Access Compliance Report

Public Rights-of-Way

(Curb Ramps)

Intersection ID: 28625	Main Street: GREYBRIAR_FOREST_LN	Cross Street: PEDLAR_MILLS_RD	Location: NW
ADA ID: 8B07421C6B72	Ramp Type: BlendTrans1	Initial Pass/Fail: Fail	Overall Compliance: No
Codes/Mitigation Info/Possible Solution			Severity Score: 35
			Field Measurements/Component Compliance

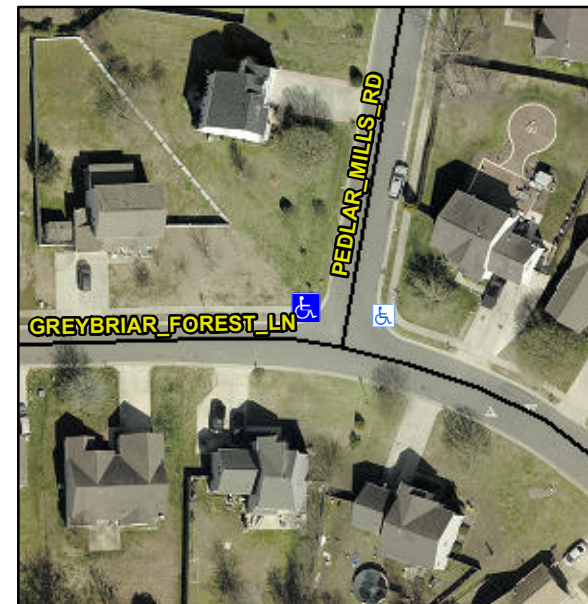
Not Found, R304.5.1

Compliance	Description	Data	Compliance	Description	Data
N/A	Ramp Length (in)	46.5	Yes	BlendTrans Slope (%)	4.2
No	Ramp Width (in)	31.0	Yes	BlendTrans XSlope (%)	1.4
N/A	Flare Type LT	N/A	N/A	Flare Type RT	N/A
N/A	Flare Slope LT (%)	N/A	N/A	Flare Slope RT (%)	N/A
N/A	Flare Traversable LT?	N/A	N/A	Flare Traversable RT?	N/A
N/A	Landing Length (in)	N/A	N/A	DWS Provided?	N/A
N/A	Landing Width (in)	N/A	N/A	DWS Contrast?	N/A
N/A	Landing Slope (%)	N/A	N/A	DWS Length (in)	N/A
N/A	Landing X Slope (%)	N/A	N/A	DWS Full Width?	N/A
N/A	Landing Curb? (Y/N)	N/A	N/A	DWS Offset (in)	N/A
N/A	Shared Landing?	N/A			
N/A	Gutter Ponding?	N/A	N/A	Gutter Slope (%)	N/A
N/A	Gutter Lip Ht (in)	N/A	N/A	Gutter X Slope (%)	N/A
N/A	Painted X Walk1?	No	N/A	Painted X Walk2?	No
	X Walk 1 Direction	To S		X Walk 2 Direction	To E
	X Walk 1 Width (in)	N/A		X Walk 2 Width (in)	N/A
	X Walk 1 Slope (%)	1.5		X Walk 2 Slope (%)	2.1
	X Walk 1 X Slope (%)	0.0		X Walk 2 X Slope (%)	0.0

N/A	Ramp inside XWalk1?	N/A	N/A	Ramp inside XWalk2?	N/A
	Road Slope (%)	1.5		Clear Space?	N/A
	Road X Slope (%)	1.2	N/A	Clear Space to XWalk (in)	N/A
N/A	Any Obstructions?	N/A	N/A	Storm Grate/Utility Hazard?	N/A
	Obstruction Type			Storm Grate/Utility Type	
		N/A			N/A
			Yes	Surface Condition? (G/P)	Good
			No	Curb Slope (%)	7.3

Remove & Replace Curb Ramp With Two New Directional Ramps or Equivalent.
